AGENDA
PLANNING AND ZONING COMMISSION MEETING
CITY OF CREVE COEUR, MISSOURI
MONDAY, DECEMBER 5, 2016

**APPLICATION TO PLANNING AND ZONING COMMISSION
#16-031 FOR THE REZONING, CONDITIONAL USE PERMIT, AND SITE
DEVELOPMENT PLAN AND BOUNDARY ADJUSTMENT APPROVAL OF A
MOBIL ON THE RUN CONVENIENCE STORE WITH GAS PUMPS AND
BRITWORX CAR WASH FACILITY LOCATED AT 11109-11141 OLIVE
BOULEVARD & 11100-11114 OAK LAKE COURT, CURRENTLY ZONED GC
GENERAL COMMERCIAL AND C SINGLE FAMILY RESIDENTIAL**

REQUEST: Kevin Kamp, of Civil & Environmental Consultants, Inc. has submitted an application on behalf of Wallis Companies (Arch Energy, LLC), for the rezoning of 11127, 11135 & 11141 Olive Boulevard, from C-Single Family Residential District to GC-General Commercial District, and for a Conditional Use Permit, Site Development Plan and Boundary Adjustment for a new Mobil on the Run convenience store with gas pumps and BriteWorx Car Wash facility encompassing 11109-11141 Olive Boulevard and 11100-11114 Oak Lake Court.

REPORT PREPARED BY: Jason Jaggi, AICP, Director of Community Development; Whitney Kelly, AICP, City Planner
DATE: 12/1/2016
ATTACHMENTS: Applicant's Materials received November 4, 2016
Traf

Figure 1: Close-up of the Applicant's Site Development Plan

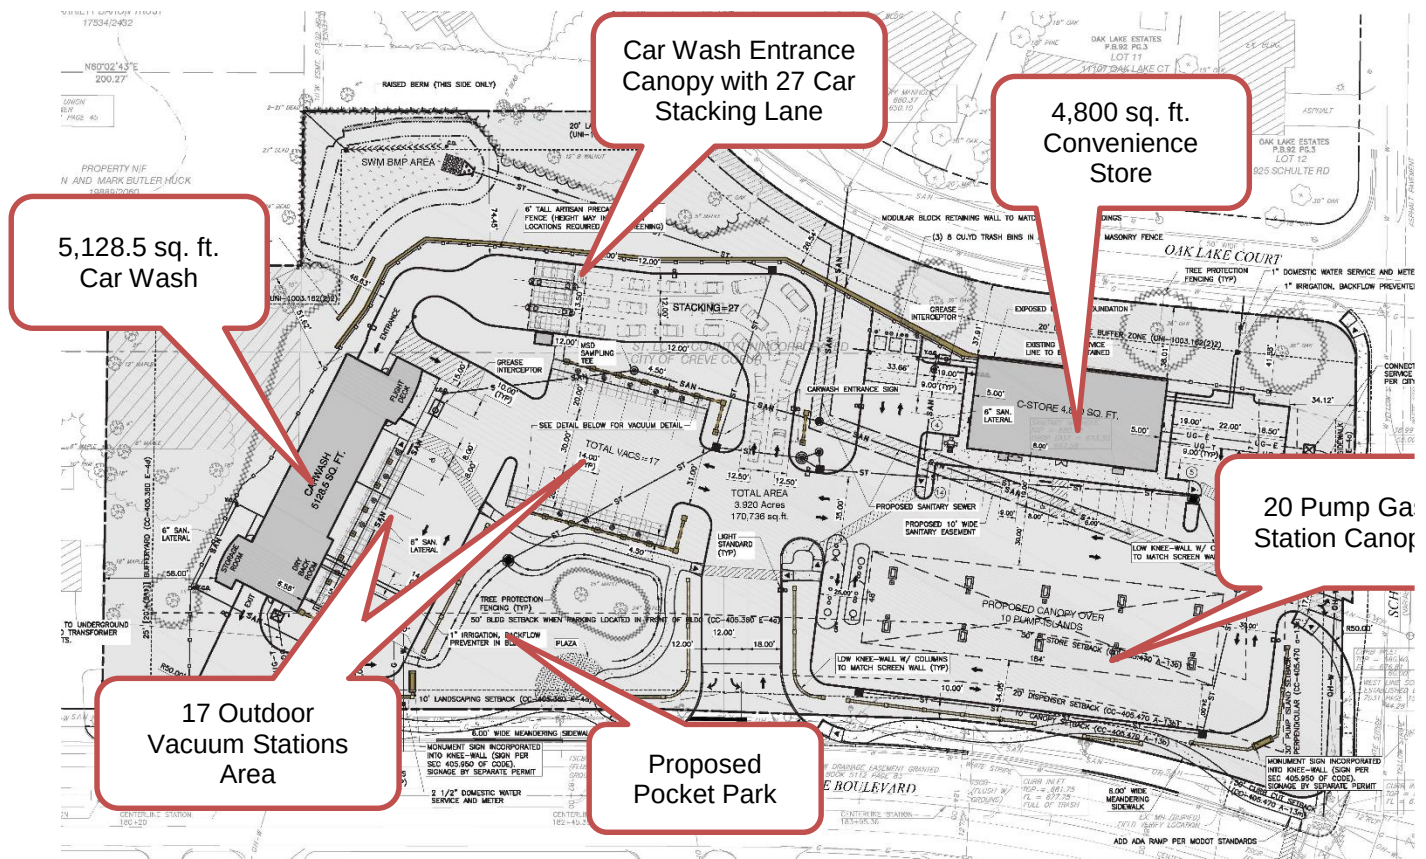
The proposed development of a gas station with a convenience store and a separate, detached car wash facility with exterior vacuum stations appears to be consistent with a few of the policies of the Comprehensive Plan; however, Staff finds the proposal to be in conflict with several significant policies of the Plan.

The development includes pedestrian amenities and landscaping treatments given the proposed auto-oriented uses. For example, the Applicant has included a pocket park with pedestrian amenities and sufficient landscaped buffer along the rear and west side of the development and low-height landscape wall feature which furthers the project toward the goals of the Comprehensive Plan. In addition, the Applicant is proposing to save several large, mature trees on the site and has incorporated them into the site planning for the project.

The proposal's primary challenges with the policies of the Comprehensive Plan involve the scale of the proposed development, the intensity of the uses at the scale which is proposed, and the compatibility of the development with the residential character of this section of Olive Boulevard. The Comprehensive Plan clearly speaks to this area of Olive Boulevard as having a vision for smaller scale retail and service businesses that cater to the surrounding residential neighborhoods. To further the goal of compatibility, the Comprehensive Plan suggests that the commercial uses themselves incorporate design elements that maintain this strong residential character. As currently proposed, Staff finds that this project is inconsistent with these elements of the Comprehensive Plan. Redevelopment of the existing facility within the existing GC District would be more in keeping with the character of the area, and the Comprehensive Plan, and standards for the GC District discussed further below.

- The degree of usability of the 'pocket park' pedestrian amenities in the proposed location and the extensive use of low walls to provide visual interest which appears to heighten the large scale of the development.

- The lack of a separated pedestrian connection from the gas pump to the main entrance of the convenience store that does not interfere with the Accessible parking area, where the Design Guidelines recommend breaking up the row of parking.
- The Design Guidelines provide specific direction regarding Auto Service Stations where separate structures, such as a canopy, carwash or cashier's booth should be avoided; however, if approved, should have a consistent design theme and a car wash that is incorporated into the project shall be well integrated into the design.

Figure 7: Close-up of the East Olive Corridor Key Properties Map of the Comprehensive Plan found on Page 55, with the subject properties boxed in red.

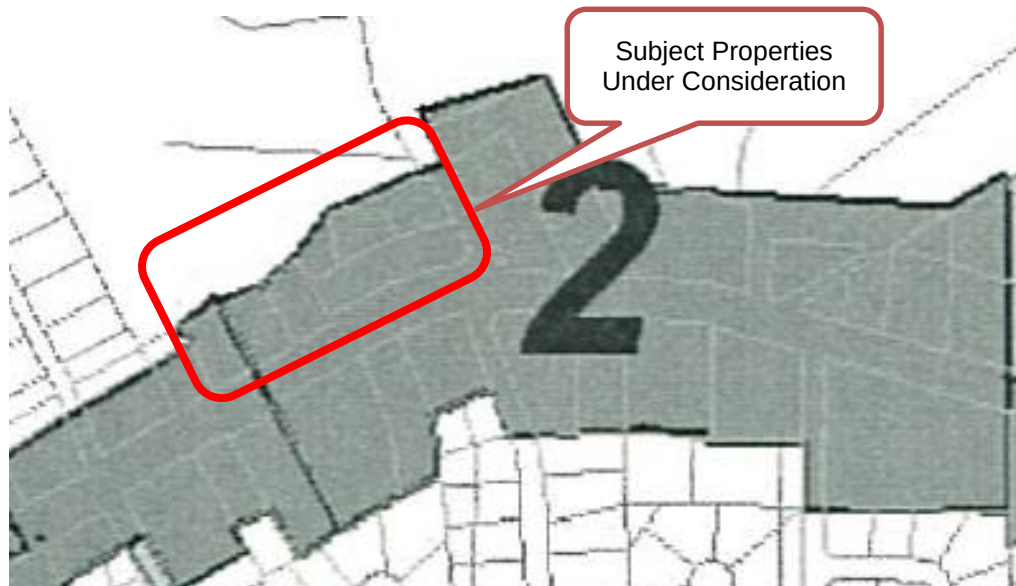
East Olive Corridor Key Property Area 2 recommends that as redevelopment and new investment occurs, the area will be encouraged to remain commercial, with uses limited to neighborhood-oriented commercial. Redevelopment should be designed to protect and be compatible with adjacent residential areas, as provided for in the *Residential Preservation and Economic Development* recommendations for the East Olive Corridor. (Page 57).

SOUTH ELEVATION- C-STORE
SCALE: 1/8" = 1'-0"

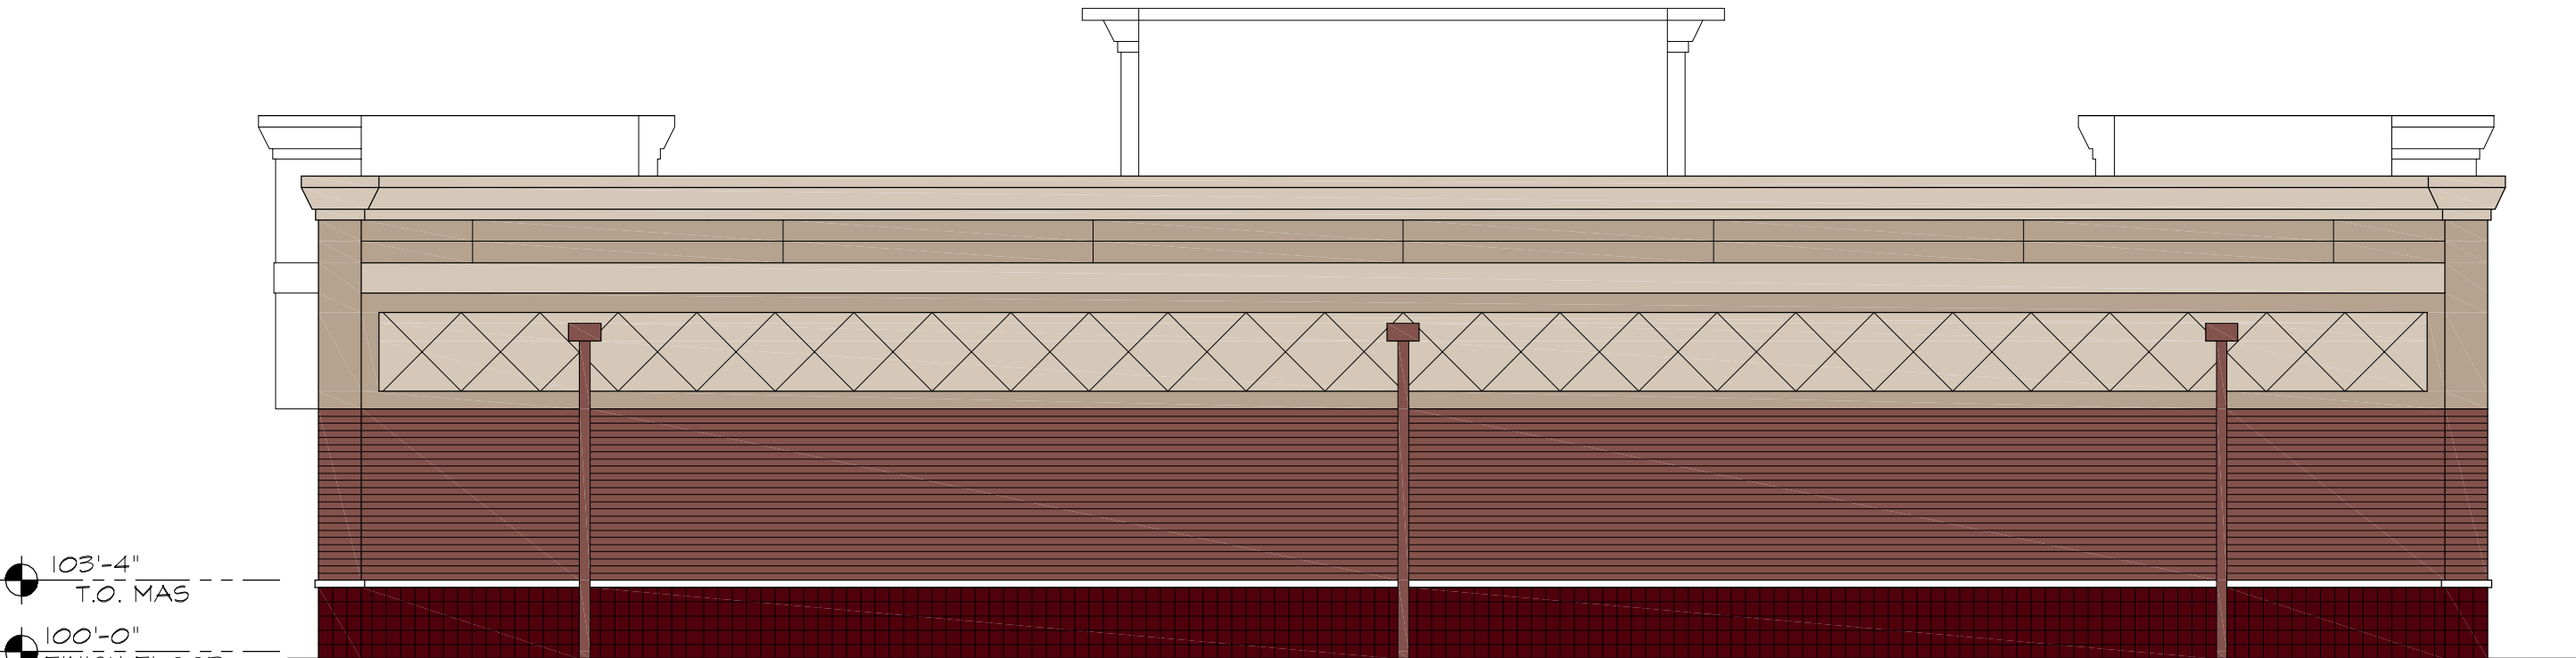
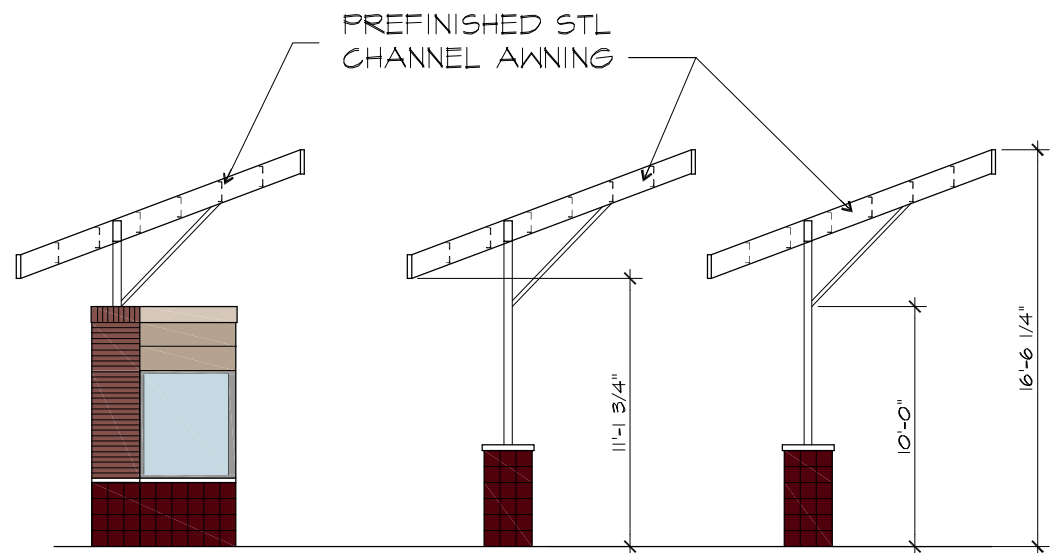
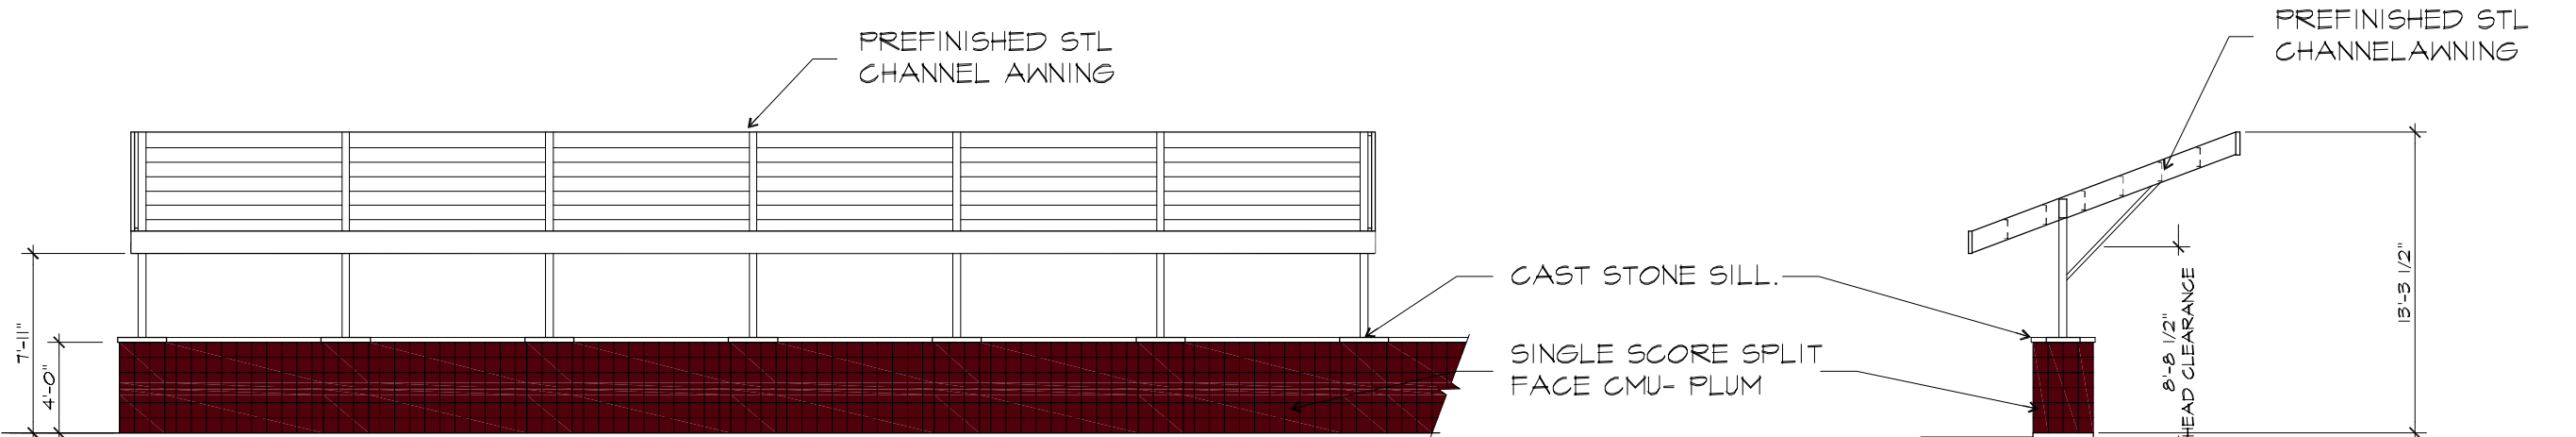
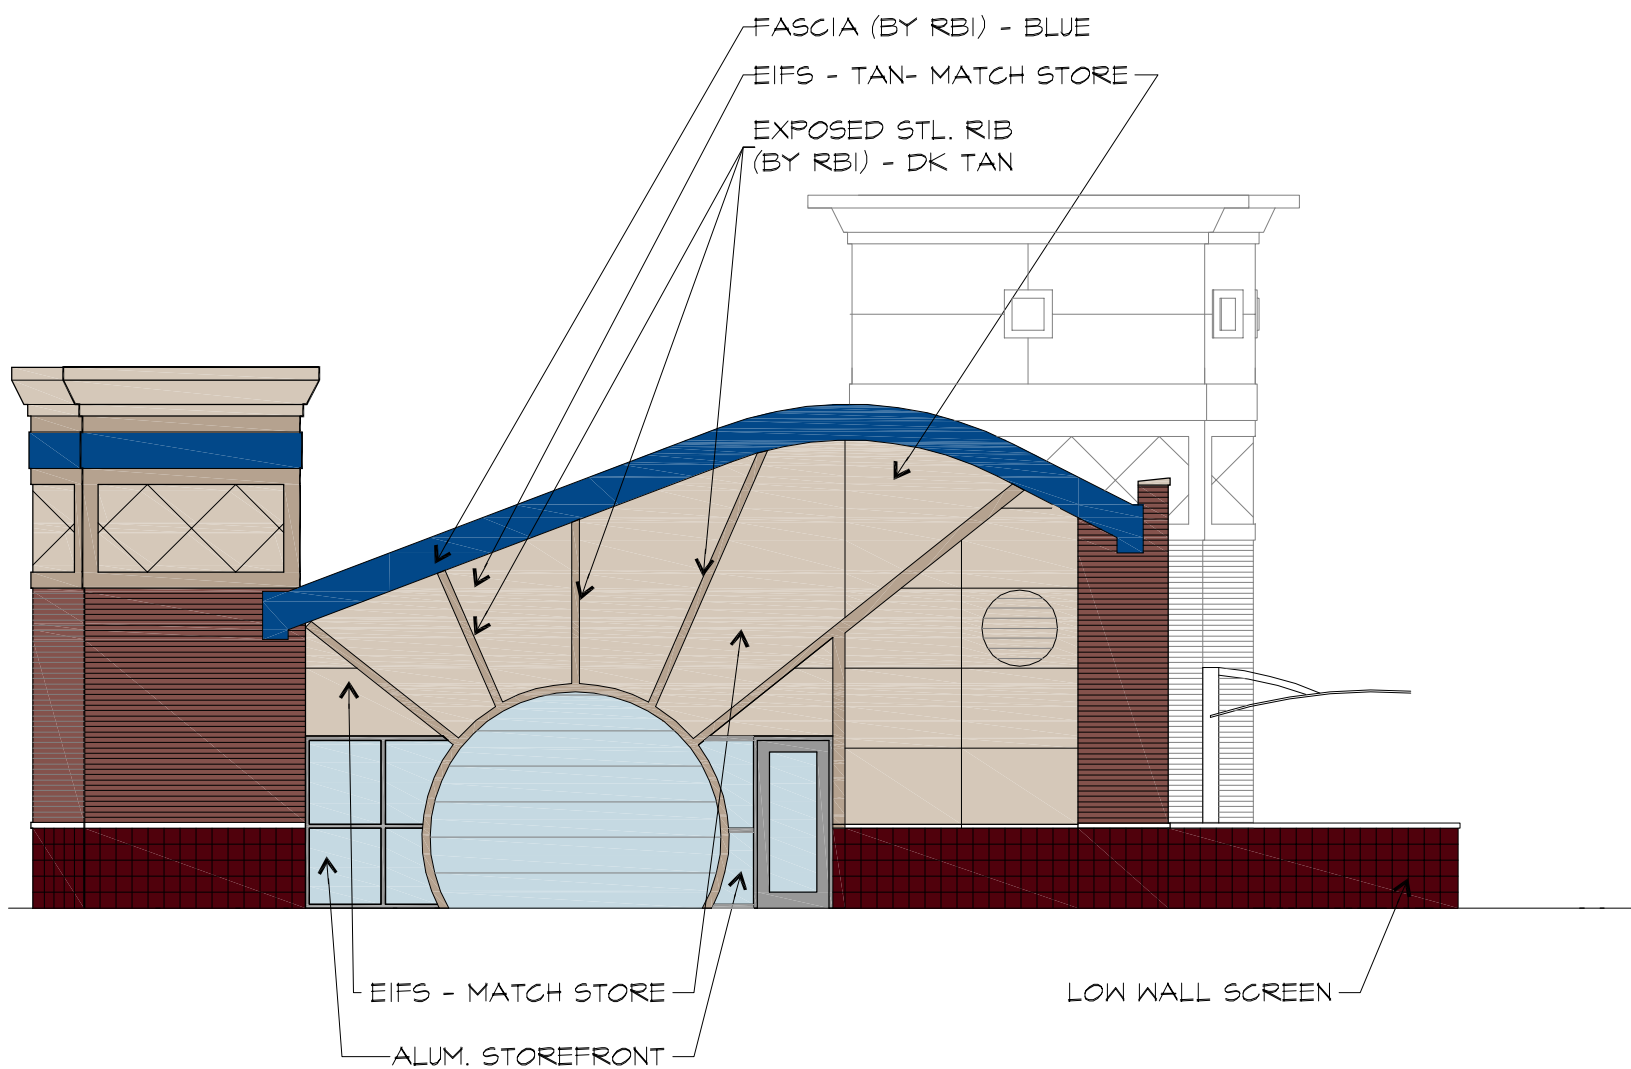
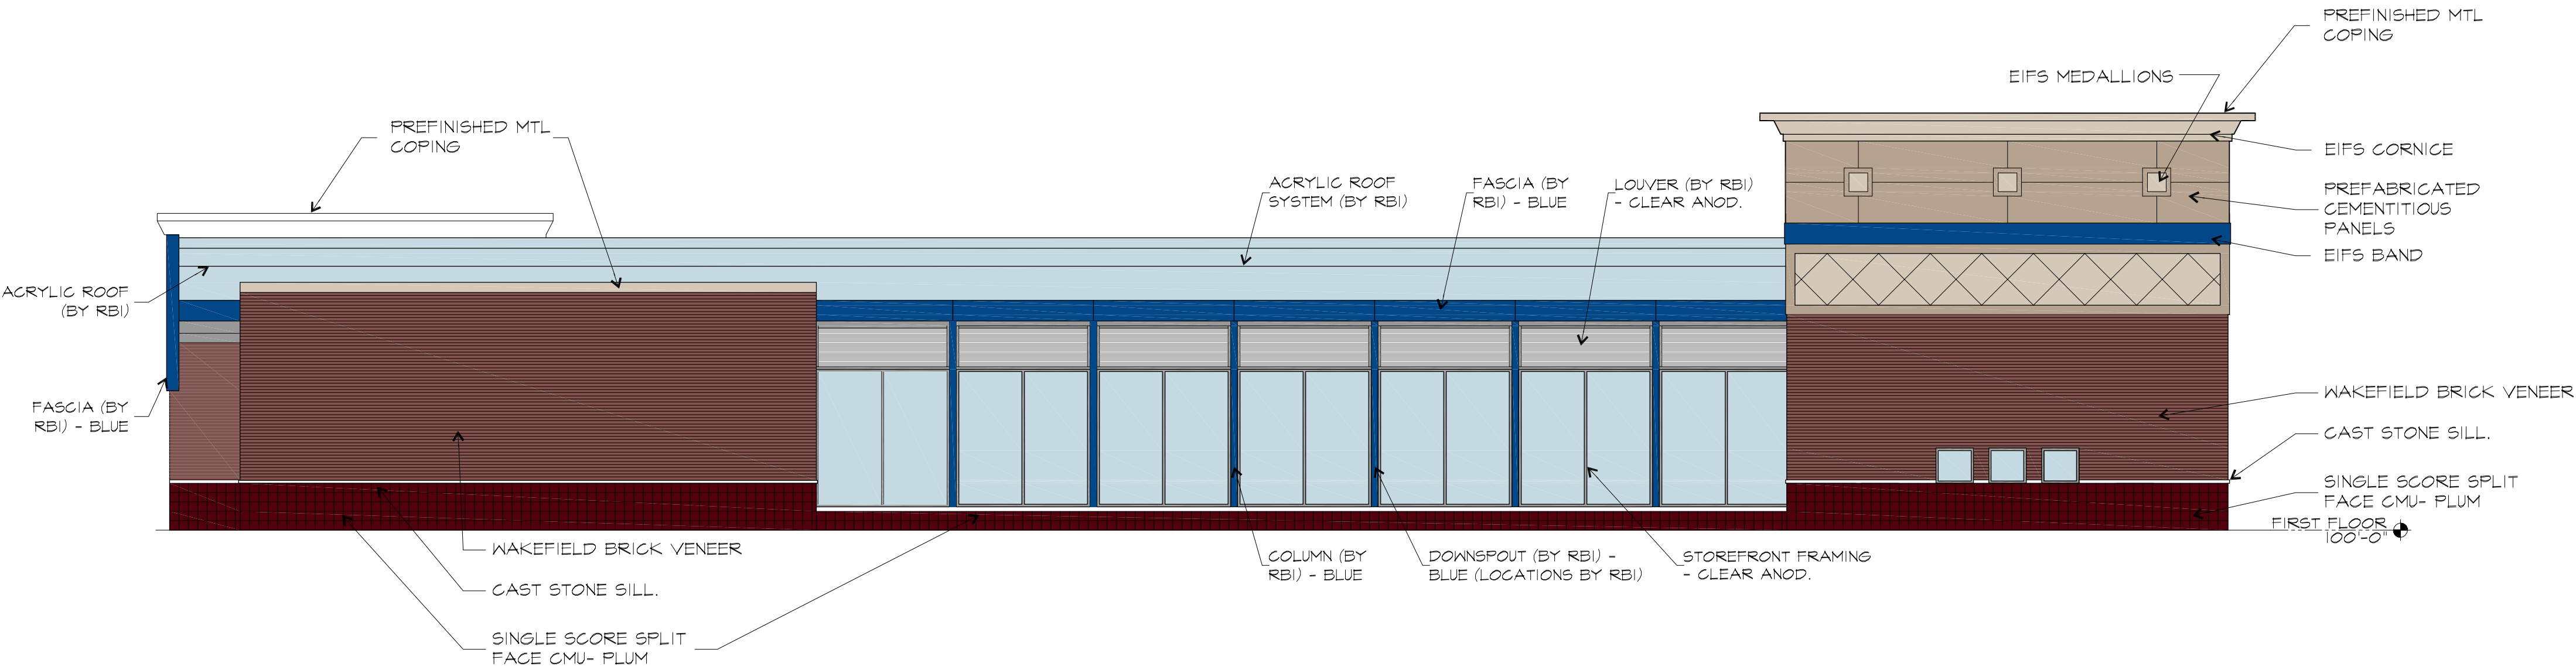
- Strong use of corporate architecture and overuse of EIFS that is strongly discouraged, and the overall design which is inconsistent with the Comprehensive Plan which calls for incorporating residential design elements to maintain the residential character of commercial buildings in this section of Olive Boulevard.
